From: Craig Houghton

CE08/0349/F4

PSUK PENGUIN SERVICES UK LTD 01544 262720 / 07867 966558 psuk@ukonline.co.uk www.p-s-uk.com	Client _____	Project ORCHARD CORNER DINEGGER CROSS HEREFORD, HR2 9PF	Title BUILDING PROPOSALS FOR TWO STOREY SIDE EXTENSION PROPOSED FLOOR LAYOUTS
	Drawn By E.B.	Date JAN 2006	Drawing No. 0212-06 revA
	Rev A. Drawing revised to planners comments.	Date 17.03.08	Scale A3 @ 1:100
	Date 17.03.08

Car Parking Provisions 1:200

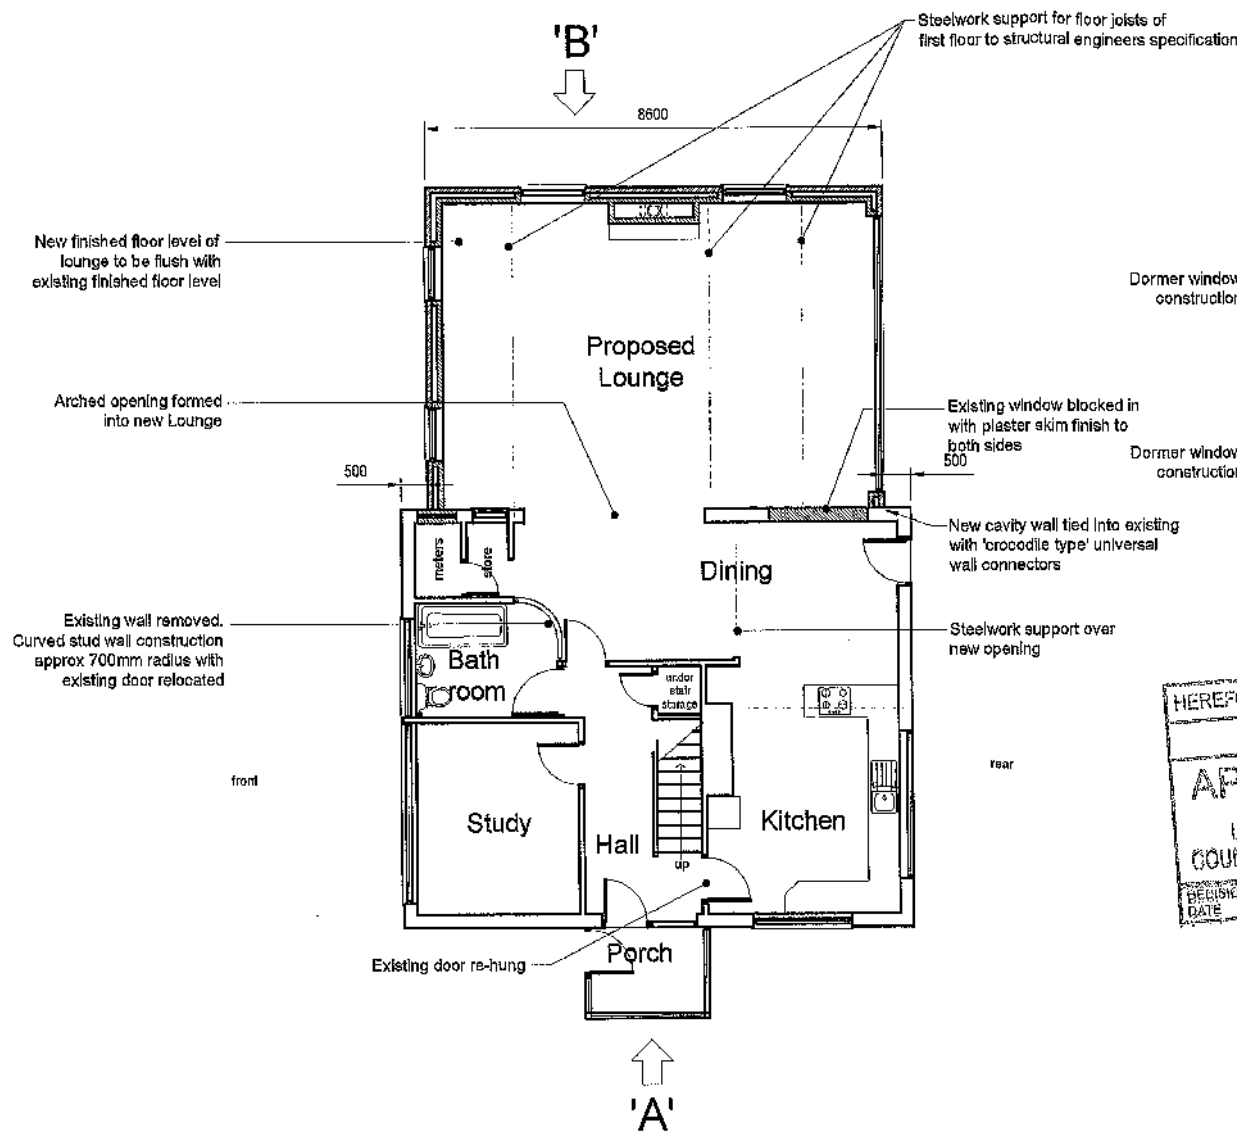
Spoken to the applicant,
Concerns over the proximity to the junction and advise him to contact Highways for further advice
